Determination 2014/008

Regarding the compliance of a wire balustrade to a house deck at 12B Broadview Road, Opuia

Figure 1: Cross section through the proposed barrier as amended

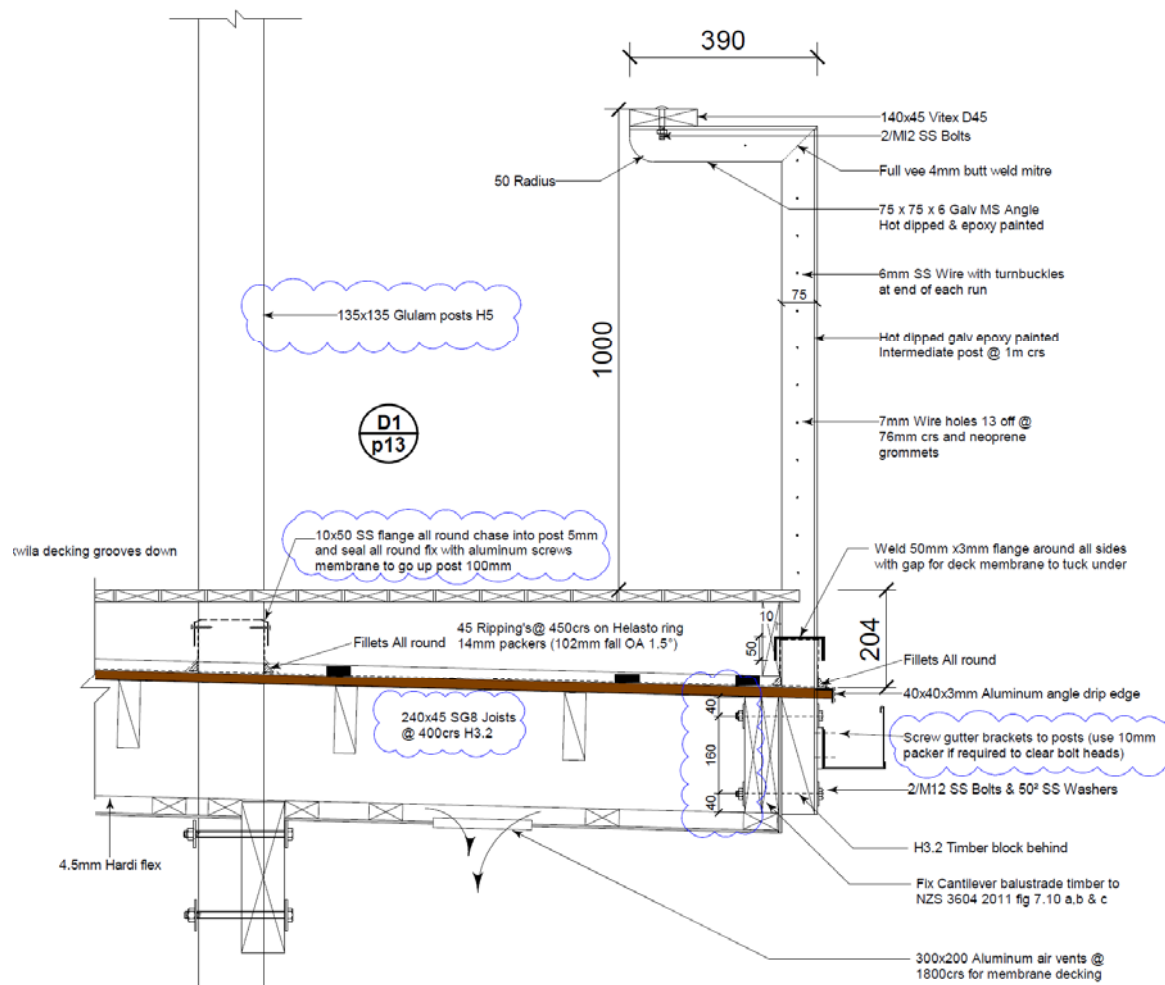
Barrier Detail is not acceptable, (Apart from no PS1 or calculations) the information provided concludes that the barrier does not comply with F4 of the New Zealand Building Code, so please redesign this barrier and show any new barrier to be face fixed and not through the membrane.

1. The [designer] has not provided supporting calculations (PS1) for this design required to demonstrate tensioning adequacy, for example what tension is required to assure that the gaps are not opened beyond 100mm and with this tension are the corner posts able to cope with the forces imposed.
2. [Determination 2011/019] correctly identified that a force of 20 Newtons is the equivalent of a 2kg mass, a five year olds average weight is 15kg therefore the calculations must reflect this potential mass for the wire deflection
3. Durability – B2. Running stainless steel cable through a galvanised post has compatibility implications that should be addressed.

3.2.1 The expert sought an opinion from a structural engineer (“the engineering adviser”) on the adequacy of the calculations provided with the application for consent. The engineering adviser considered that further information was required to demonstrate compliance, noting that:

- the moments in the balusters due to the barrier loads are calculated but the baluster itself is not checked
- the wire tension loads to the end balusters and top rail are based on 11 strands, whereas the drawings specify 13

- the moments in the end balusters due to tensioning loads are calculated but the baluster itself is not checked including any torsion due to the eccentricity between the tension loads in the strands and the compression load in the top rail

- clarification is required of the span used to calculate the moment in the balusters due to the tensioning load; 1.3m used for barrier loads, 1.0m for tensioning loads

- the connection of the top rail to the end balusters is not checked; the detail calls up 2xM12 bolts but shows only one
- the bolt spacing for the baluster fixings is not specified

- the plan view requires clarification; the balusters are indicated as 75x75x6 steel angles but the plan view appears to indicate a T-section with staggered bolts.

3.3.1 The expert noted the requirements of Clause B2 were durability periods of 50 years for the balustrade posts and 15 years for balusters. The expert considered that the wires, as balusters, can be expected to exceed the 15 year period provided they are grade 304, or 316 if no surface rusting is acceptable.

3.3.2 In respect of the balustrade posts, the expert noted that the posts are exposed, visible, and not difficult to access. The expert noted that the epoxy coating would reach the end of its service life sometime after 15 years but before 50 years and that the galvanising would protect the balustrade for a further period. The expert was of the view that if the steel was exposed it would very soon rust, and that the rust stains would be visible and attended to as normal maintenance.

3.3.3 The expert noted that the design includes separation between the wires and the posts by way of neoprene grommets and the epoxy coating applied to the posts and therefore little risk of galvanic corrosion from direct contact.

3.3.4 The expert observed that H3.2 treated blocks are shown between the posts and the supporting structure, and that the CCA treatment of the blocks would lead to erosion of galvanising if they were in contact, though the epoxy coating should prevent this. The expert considered better separation could be provided.

The tension required in the wires is not specified on the drawings and even if it was how does the builder measure that unless the turnbuckles on the wires are load calibrated (and you can buy them but they are very expensive). It seems to me that the only way of checking if the tension in the wires is sufficient to satisfy the 100mm requirement is an on site check after construction with the test following the procedure outlined in Appendix C NZS 8500:2006⁷.

4.3 The designer responded by email on 5 February 2014, noting that the rail design had been revisited and attaching a revised handrail design in response to the determination. The designer provided the revised design and a PS1 dated 4 February 2014, and also noted that the posts are not in contact with CCA treated timber as there is 6mm fibre-cement sheet in between (refer paragraph 3.3.4).

- 5.3.4 The designer has subsequently provided a revised design and a new PS1, dated 4 February 2014, which has been reviewed. I accept the opinion of the engineering adviser and conclude that the revised design complies with Clause B1 of the Building Code.

- 5.6.1 For the reasons set out above, I consider that the proposed barrier, as detailed in the revised design complies with Clauses B1, B2, and F4.3.4(c) and (d) of the Building Code. I also consider that compliance with Clause F4.3.4(g) can be verified using the test method described in the Ministry's guidance document.

- 6.1 In accordance with section 188 of the Building Act 2004 I hereby determine that the revised design of the proposed barrier complies with Clauses B1, B2, F4.3.4(c) and F4.3.4(d). I also determine that compliance with Clause F4.3.4(g) can be verified using the test method described in the Ministry's guidance document.
